# National Committee on Uniform Traffic Control Devices

**Attachment No.: 17  
Item No.: 18B-BIK-06**

## NCUTCD Proposal for Changes to the Manual on Uniform Traffic Control Devices

**TECHNICAL COMMITTEE:** Bicycle Technical Committee  
**ITEM NUMBER:** 18-BIK-06  
**TOPIC:** Bicycle Detector Symbol Marking  
**ORIGIN OF REQUEST:** NCUTCD Bicycle Technical Committee  
**AFFECTED SECTIONS OF MUTCD:** Sections 9C.05

**9C-7. Bicycle Detector Pavement Marking**  
 [The following to the existing symbol:]

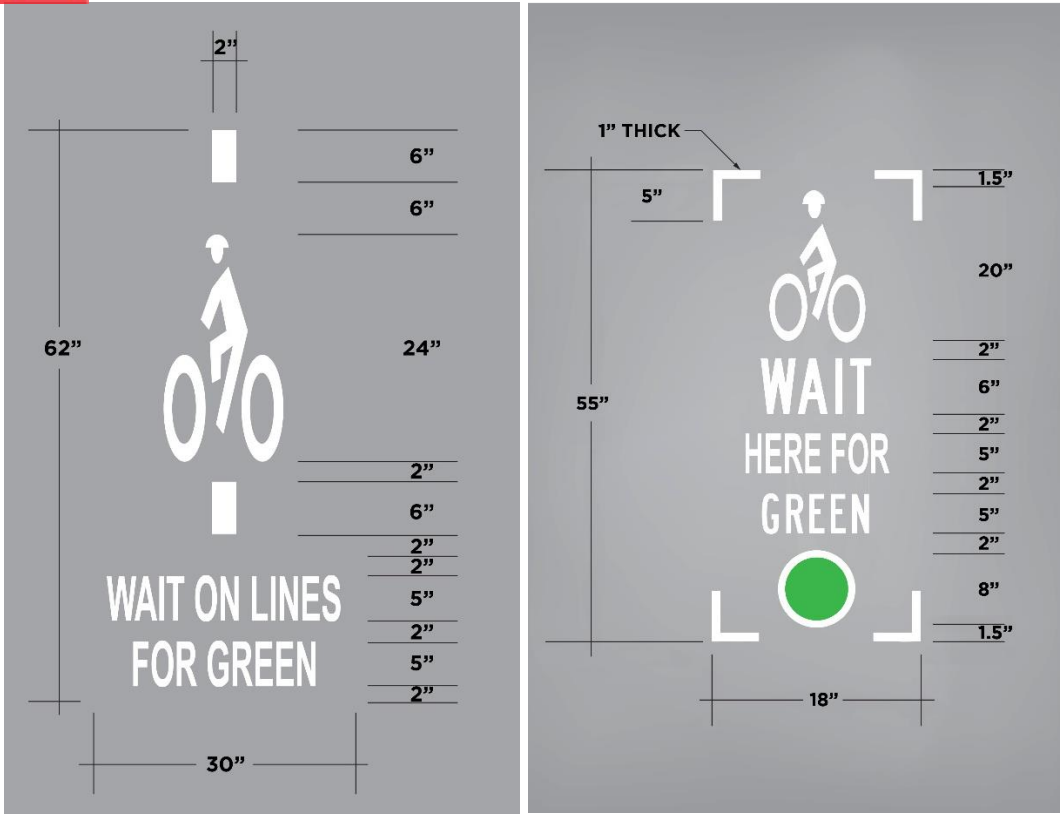
01 A symbol (see Figure 9C-7, 9C-7A or 9C-7B) may be placed on the pavement indicating the optimum position for a bicyclist to actuate the signal. Any other appropriate similar symbol in a traffic signal face can be used to replace the green circle identified in Figure 9C-7B, such as a bicycle symbol or green arrow.

02 An R10-22 sign (see Section 9B.13 and figure 9B-2) may be installed to supplement the pavement marking.
